# TECHNICAL BULLETIN

[Issue No.] T10-0019-A

[Title] Production Discontinuation of the GOT800 Series

[Relevant Models] GOT800 Series

#### (a) Depth of the GOT

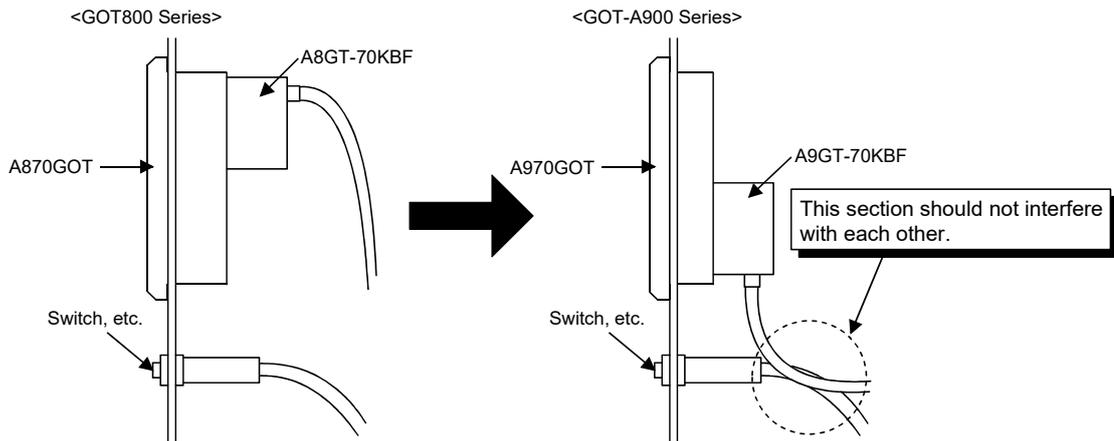
Some models require more depth inside the control panel, etc. than previous models. The following shows the depths required for model replacement.

GOT800 Series in use	GOT-A900 Series to be transferred	Corrective action
A870GOT-EWS (Depth: 83mm (3.27 inch))	A960GOT (Depth: 43mm (1.69 inch))	No action is required (The depth should be smaller than the former models.)
A870GOT-SWS (Depth: 81mm (3.19 inch))	A970GOT-SB* (Depth: 40mm (1.57 inch))	
A870GOT-TWS (Depth: 81mm (3.19 inch))	A970GOT-TB* (Depth: 40mm (1.57 inch))	
A85*GOT (Depth: 56mm (2.20 inch))	A95*GOT (Depth: 51mm (2.01 inch))	
A810GOT (Depth: 88.4mm (3.48 inch))	A985GOT (Depth: 43mm (1.69 inch))	The depth should be larger than the former models.
A852GOT (Depth: 63mm (2.48 inch))	A956GOT+ A8GT-J61BT15 (Depth: 85(51+34)mm (3.35 (2.01+1.34) inch))

### (a) Replacing the A870GOT with the A97\*GOT/A960GOT

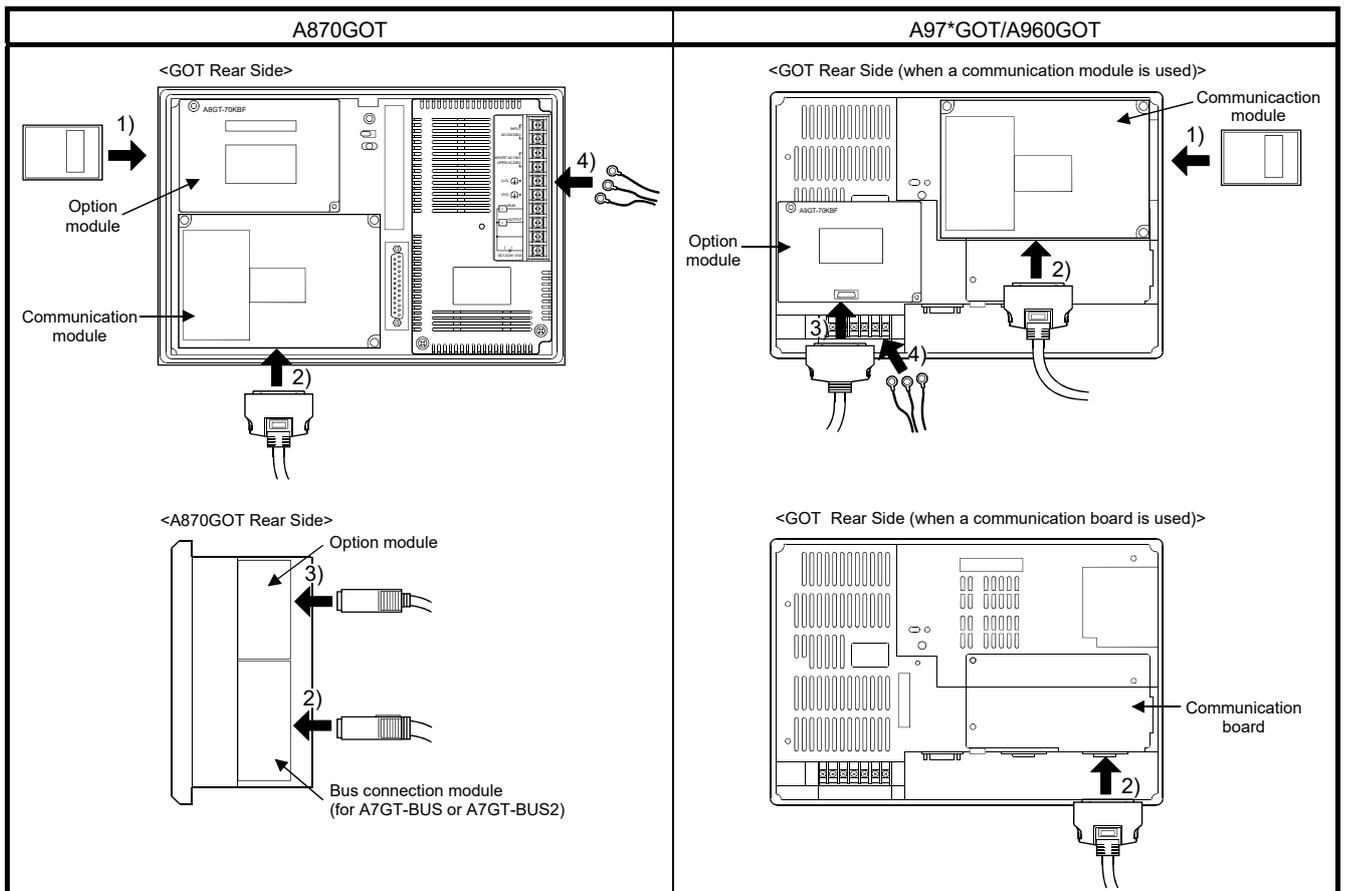
The GOT800 Series and the GOT-A900 Series have a different cable pullout direction and position, as well as a PC card mounting direction.

Item	Mounting position on GOT		Notes
	A870GOT	A97*GOT/A960GOT	
1) Position of PC card	Left side	Right side	Allocate sufficient space from the device at the right of the GOT, so that the PC card can be inserted/removed.
2) Cable connect direction (Bus connection module (Large connector type: A7GT-BUS, A7GT-BUS2))	Rearward	Downward	Bus connection module (Large connector type: A7GT-BUS, A7GT-BUS2) is not present in GOT-A900 series, therefore cable connect direction has been changed.
	Position of communication Module	Lower left side	Upper right side
3) Cable connect direction of option module	Rearward	Downward	If any device is installed under the GOT, the cable of the option module and the device should not interfere with each other.
4) Position of power supply terminals	Upper right side	Lower left side	Change the routing of the power supply line.

**(b) Replacing the A850GOT/A851GOT/A853GOT with the A950GOT/A951GOT/A953GOT**

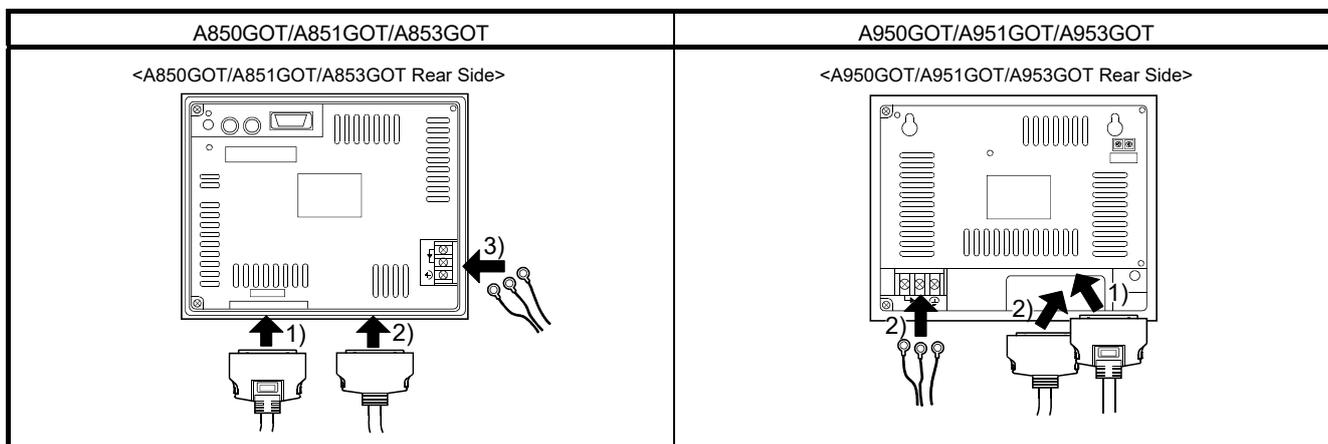
Item	Mounting position on GOT		Notes
		A850GOT A851GOT A853GOT	A950GOT A951GOT A953GOT	
1)	Position of communication connector	Lower left side	Lower right side	If any device is installed under the GOT, the communication cable and the device should not interfere with each other.
2)	Position of option module interface	Lower rightward	More rightward than the former position	If any device is installed under the GOT, the cable of the option module and the device should not interfere with each other.
3)	Position of power supply terminals	Lower right side	Lower left side	Change the routing of the power supply line.

**(c) Replacing the A850GOT with the A956GOT (mounted with a communication module)**

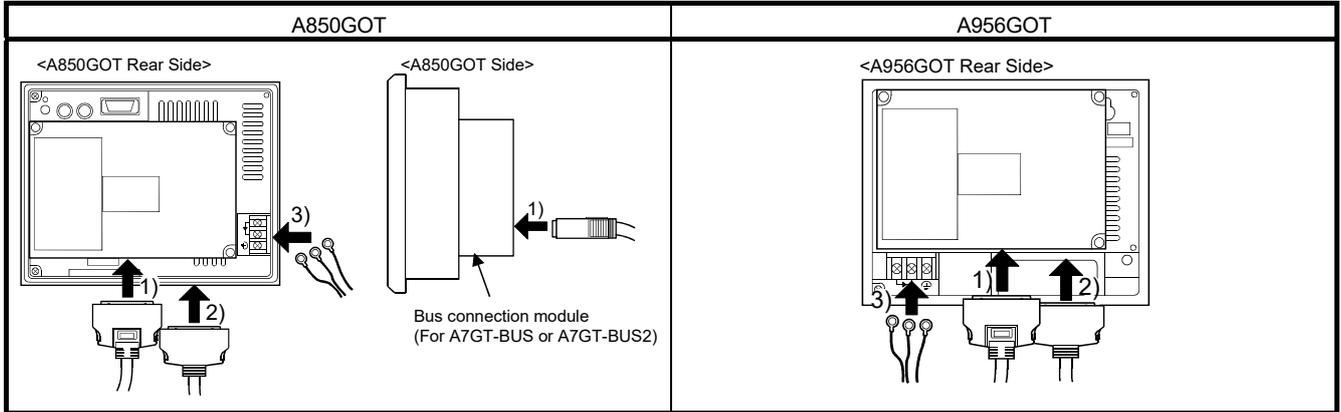
Item	Mounting position on GOT		Notes
	A850GOT	A956GOT	
1) Communication cable connect direction	Rearward	Downward	Only applicable when changing from A7GT-BUS/BUS2 to A9GT-BUSSU/BUS2SU.
1) Position of communication module	Left side	More rightward than the former position	If any device is installed under the GOT, the communication cable and the device should not interfere with each other.
2) Position of option module interface	Lower rightward	More rightward than the former position	If any device is installed under the GOT, the cable of the option module and the device should not interfere with each other.
3) Position of power supply terminals	Lower right side	Lower left side	Change the routing of power supply line.

**(d) Replacing the A852GOT with the A956GOT + A8GT-J61BT15**

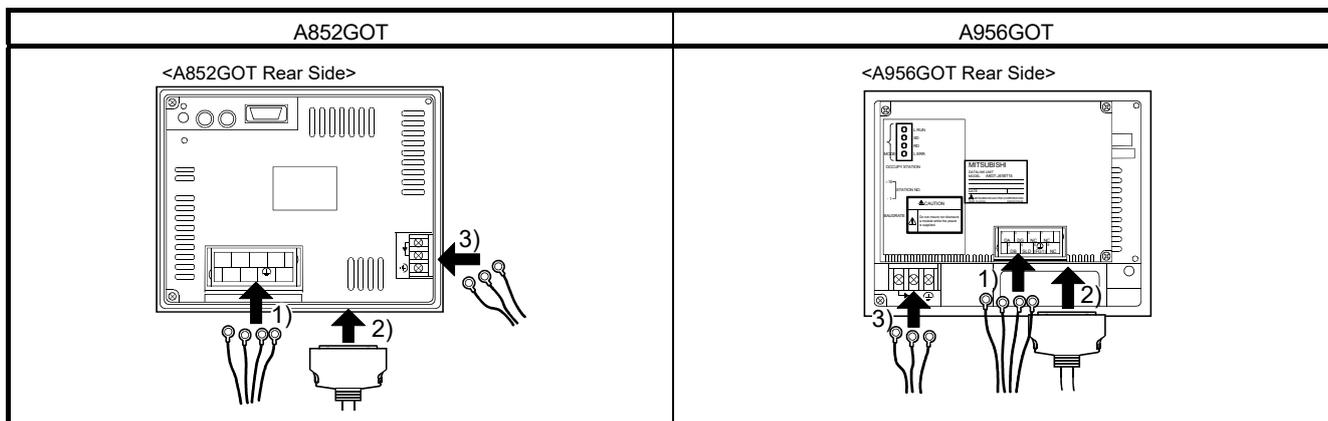
Item		Mounting position on GOT		Notes
		A852GOT	A956GOT(with A8GT-J61BT15)	
1	Position of communication terminals	Lower left side	Lower right side	If any device is installed under the GOT, the CC-Link dedicated cable and the device should not interfere with each other.
2	Position of power supply terminals	Lower right side	Lower left side	Change the routing of the power supply line.
3	Position of option module interface	Lower rightward	More rightward than the former position	If any device is installed under the GOT, the cable of option module and the device should not interfere with each other.

### (3) Bus connection cable (large connector type)/RS-422 cable

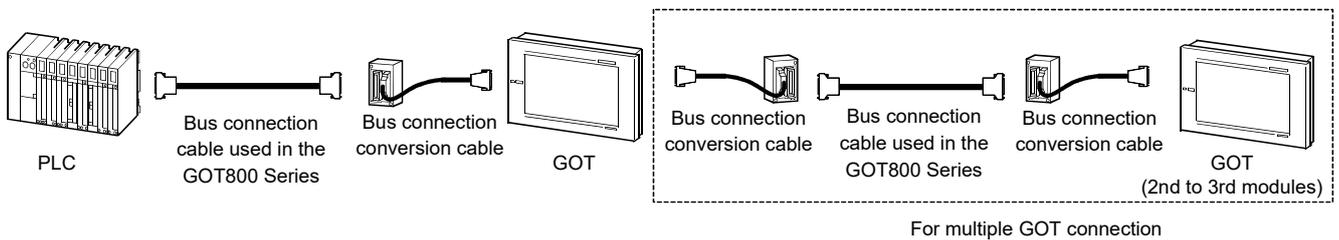
The GOT800 and GOT900 series have different communication connectors. Therefore, the bus connection cable (large connector type) and the RS-422 cable should be changed.

However, the existing cables are usable with the bus connection conversion cable\*<sup>1</sup> and the RS-422 communication conversion cable\*<sup>1</sup>.
